Integrated Device Technology, Inc.
6024 Silver Creek Valley Road, San Jose, CA - 95138

PRODUCT/PROCESS CHANGE NOTICE (PCN)

PCN #: A1911-01	DATE: 26-Nov-2019	MEANS OF DISTINGUISHING CHANGED DEVICES:
Product Affected: FCBGA53 and FCBGA253 (Refer to attachment II for affected part#)		<input checked="" type="checkbox"/> Product Mark 2D barcode on product marking <input type="checkbox"/> Back Mark <input type="checkbox"/> Date Code <input type="checkbox"/> Other
Date Effective: 26-Dec-2019		
Contact: IDT PCN DESK	Attachment: <input checked="" type="checkbox"/> Yes <input type="checkbox"/> No	
E-mail: idt-pcn@lm.renesas.com	Samples: Please contact your local sales representative for sample request.

ATTACHMENT I - PCN # : A1911-01

2D Barcode Information

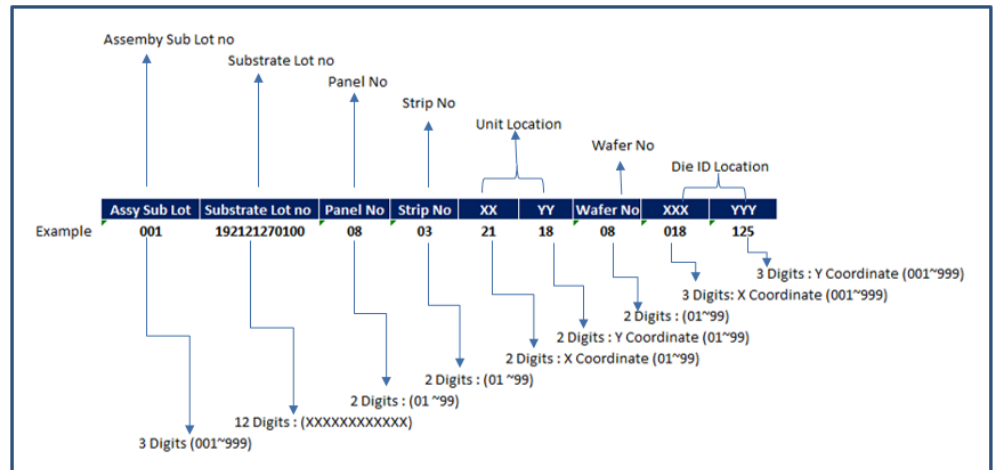
This notification is to advise our customers that IDT is adding 2D barcode on the product marking to improve traceability. The 2D barcode contains wafer and substrate information.

RCD: 13.5 x 8.0 mm

DB: 7.5 x 3.0 mm

DDR4 RCD Marking Format and Dimension

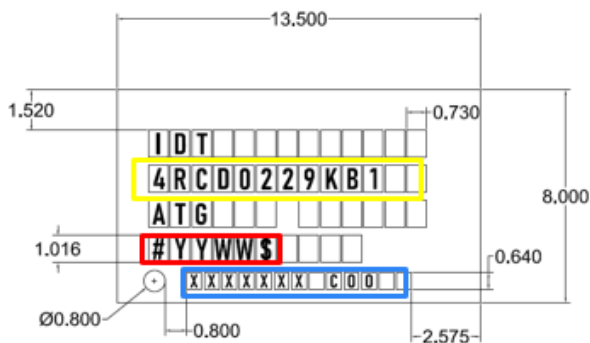
CURRENT MARKING

NEW MARKING

- Fixed Substrate level 2D ID Content
 - 17 digit max
 - Lot no (12) + PP + SS
- Combine Sublot + Substrate 2D ID info + Unit code + wafer and die ID and mark into IDT Unit
 - Total 31 digits
 - Assembly Sublot (3)
 - substrate Lot no (12)
 - Panel No PP(2)
 - Strip No SS(2)
 - Unit Location , XXY(4)
 - Wafer ID WW(2)
 - Die Location XXXYYY (6)

DDR4 DB Marking Format and Dimension

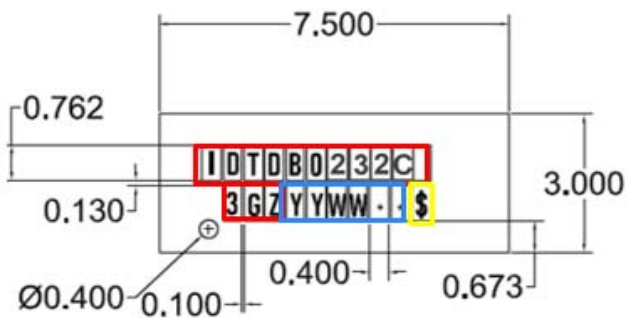
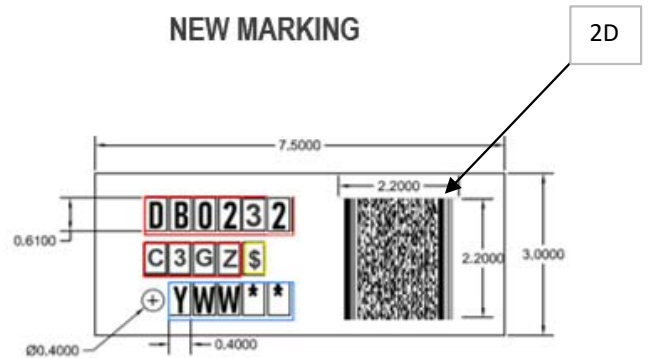
CURRENT MARKING

NEW MARKING

- Fixed Substrate level 2D ID Content
 - 17 digit max
 - Lot no (12) + PP + SS
- Combine Sublot + Substrate 2D ID info + Unit code + wafer and die ID and mark into IDT Unit
 - Total 31 digits
 - Assembly Sublot (3)
 - substrate Lot no (12)
 - Panel No PP(2)
 - Strip No SS(2)
 - Unit Location, XXYY(4)
 - Wafer ID WW(2)
 - Die Location XXXYYY (6)
